TO: Urban Design Commission
FROM: David C. Dryer, City Traffic Engineer & Parking Manager
SUBJECT: 333 West Washington Avenue project

Re: Letter of Intent, Capitol West (Phase II), PUD – SIP

Project: Capitol West – Phase II, Hyatt Place Hotel
333. W. Washington Ave.

**Re: Urban Design Commission Submittal – Initial/Final approval requested
Capitol West (Phase II), PUD – SIP
UDC GDP comments addressed**

DATE

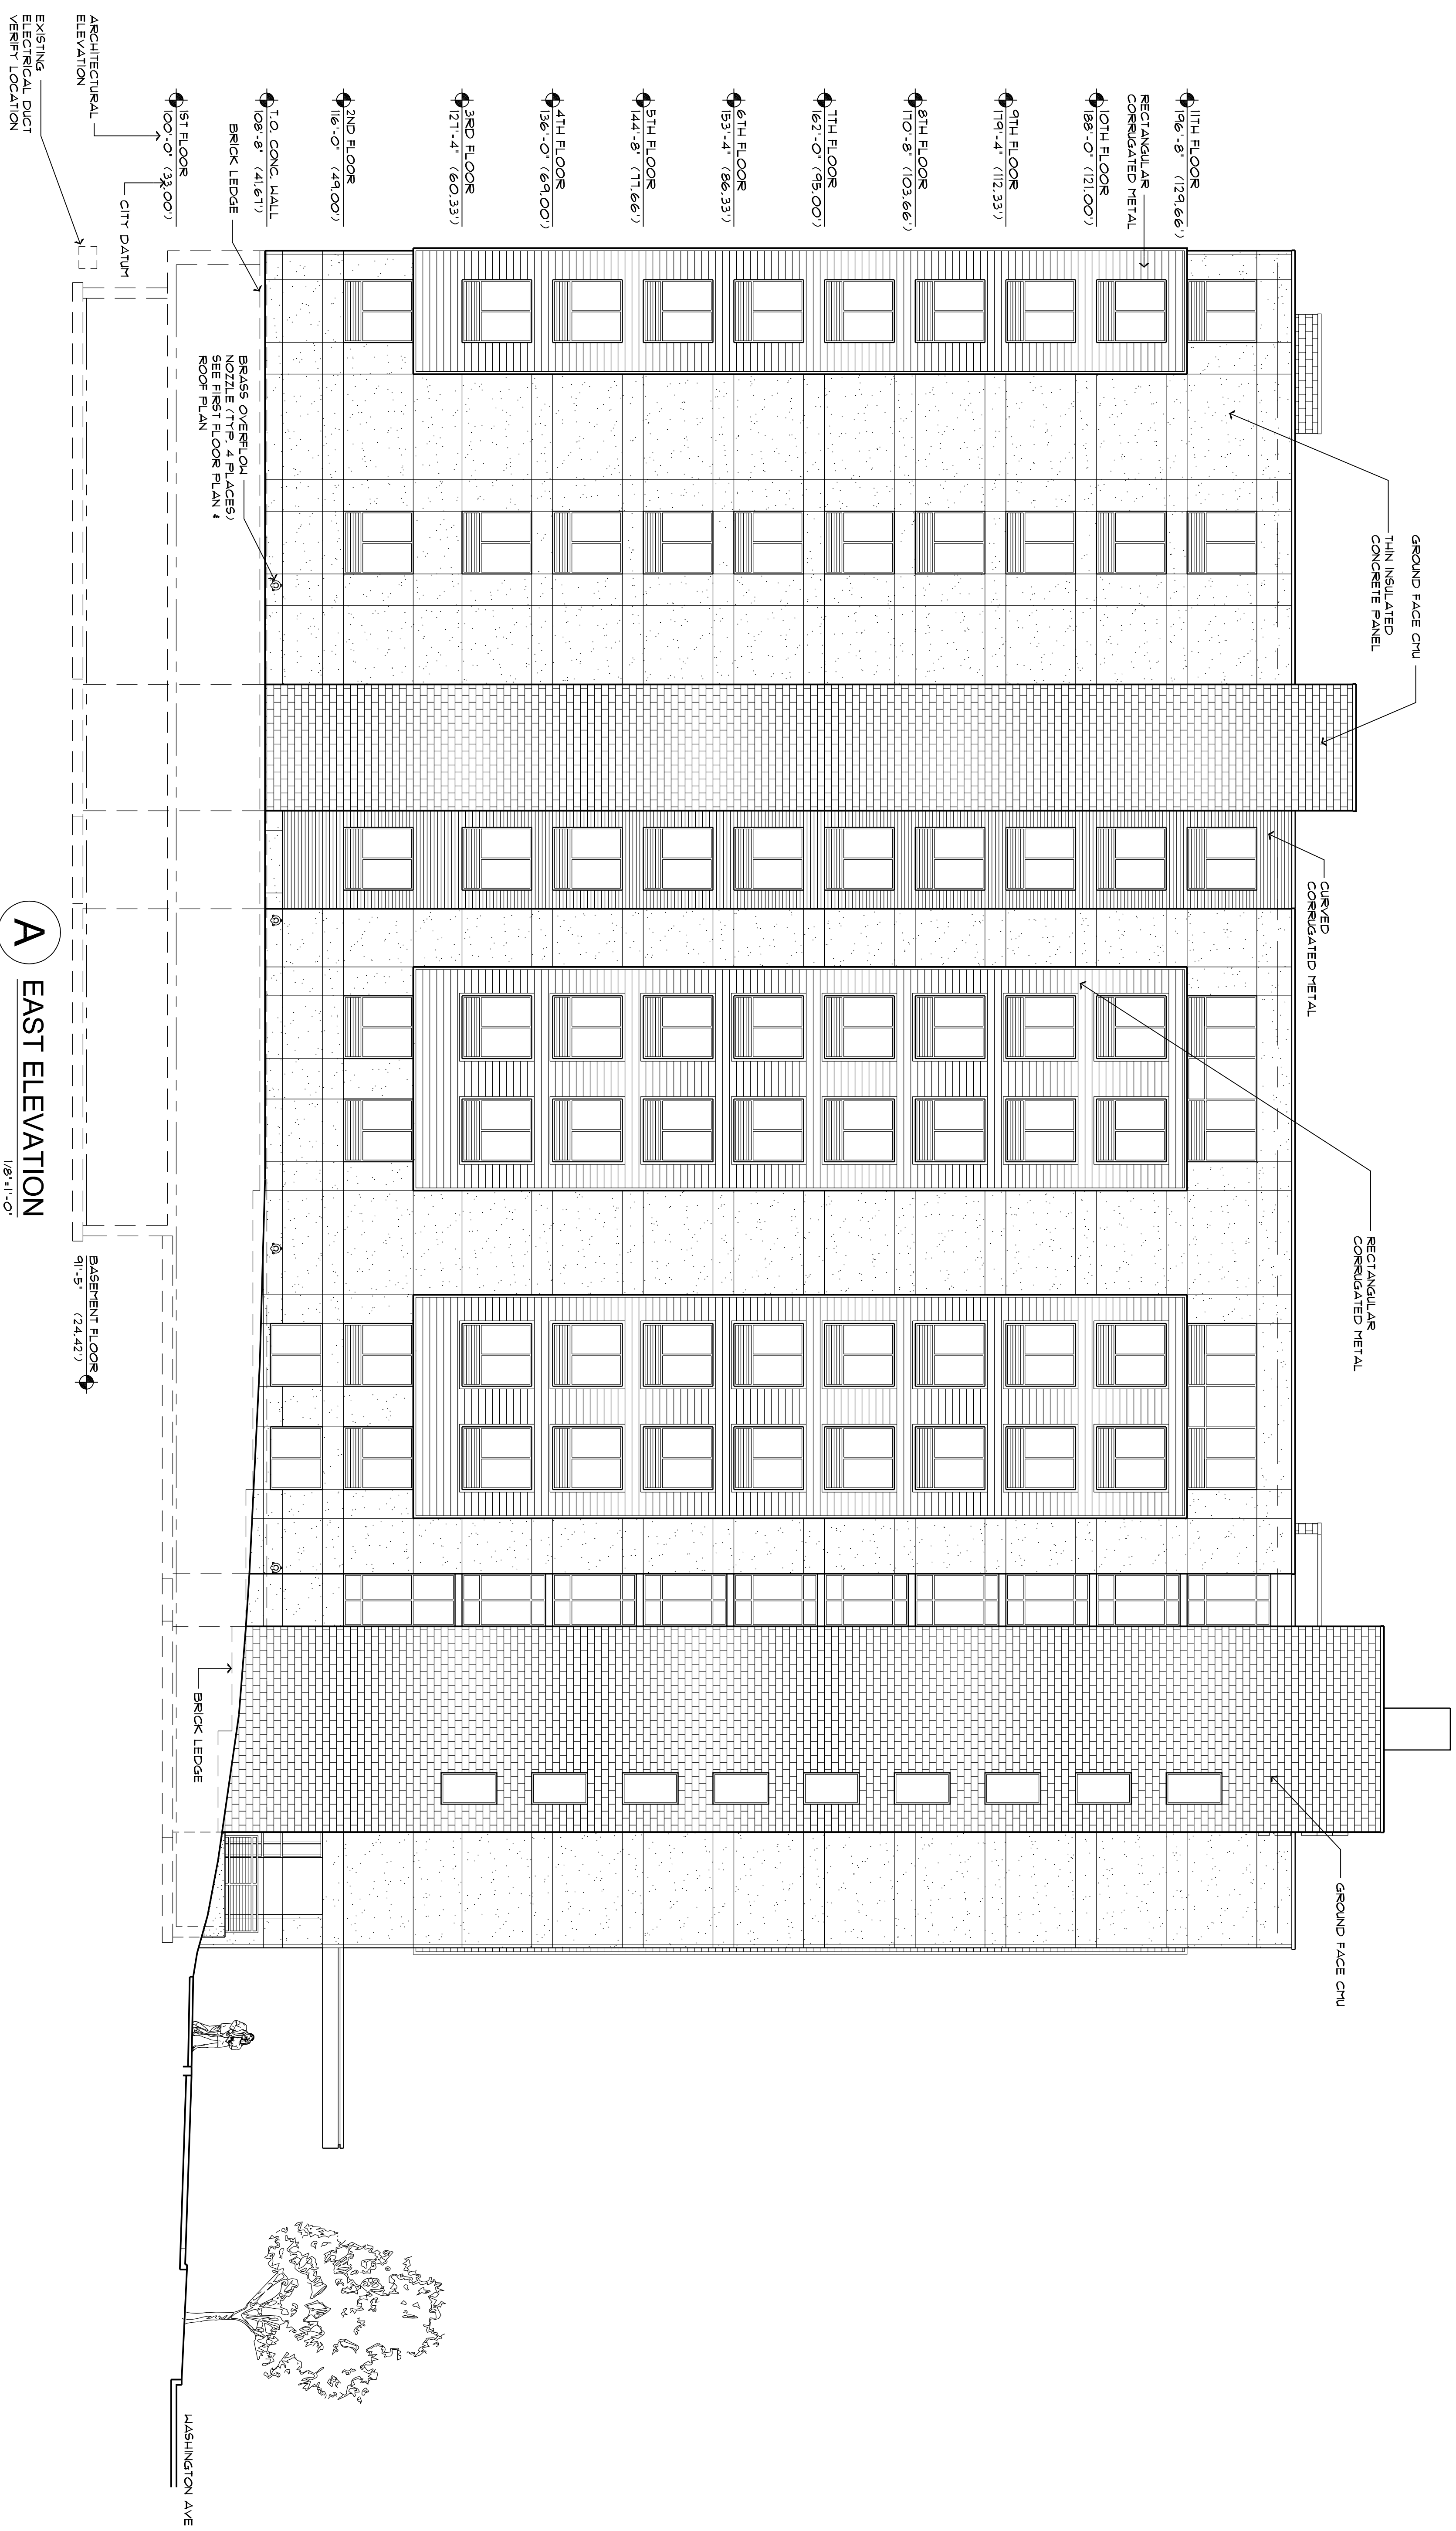
- C** Copper projecting bay too low on the Washington Place
 - R** Copper panels on east elevation have been raised. (Note: copper panels on all facades have been raised.)

- C Neighborhood viewscape around the building.
 - R The east and south façades have been modified to provide more visual interest from the Mews (east facade) as well as the south by wrapping the corner with corrugated panels.
- C Green Roof.
 - R Not currently planned.
